# Certified Action of the City of Raleigh Planning Commission

**Case File / Name:** GH-4-11 / Spring Forest Road Apartments

**SUBJECT:** GH-4-2011 / Spring Forest Road Apartments

## Staff Report

GH-4-11 Spring Forest Road – Building Layout

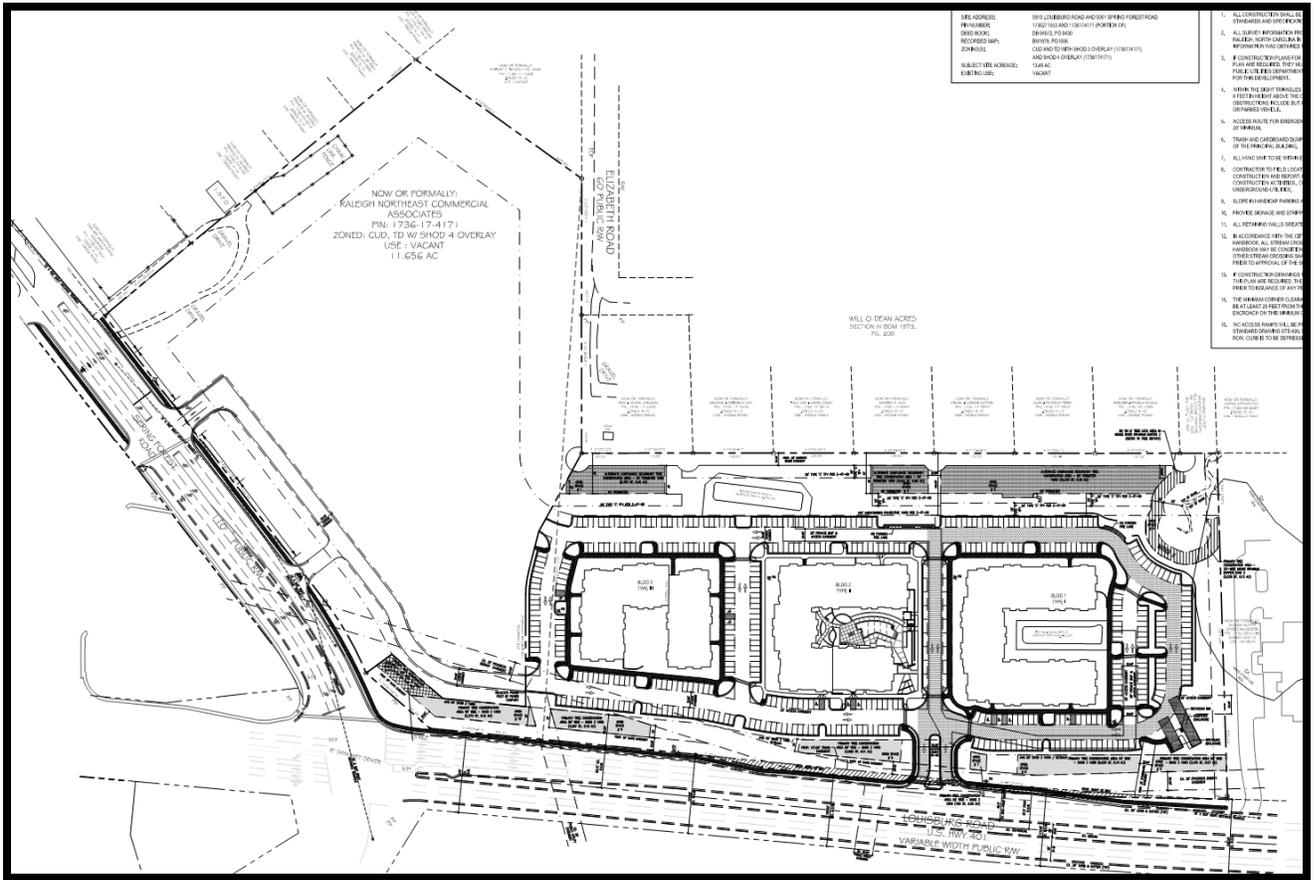
**Key Issues:** Plan does not show construction of the cross access driveway to the north property line per zoning condition (q) and Comprehensive Plan Policy LU 4.5.

- (1) That the Planning Commission finds that the site plan meets the eight standards for approval, Code Section 10-2132.2(d)
- (2) That prior to construction drawing approval the site plan be revised to show construction of the driveway along with the dedication of the cross access easement to the northern property line consistent with Zoning condition (q) and Policy LU 4.5;

The plan does not show the construction of the cross access easement to the property to the north, which is inconsistent with this policy.

**CIRCULATION:** Proposed street improvements shall conform to normal City construction standards. A 30' cross access easement is provided to the adjacent property to the north; however, staff is requesting the construction as well as the dedication of the cross access easement/driveway. The plans do not show the construction of this cross access driveway. A 20' access easement/agreement is being provided on the adjacent parcel to the south to meet the code requirement of having one access point for every 150 dwelling units.
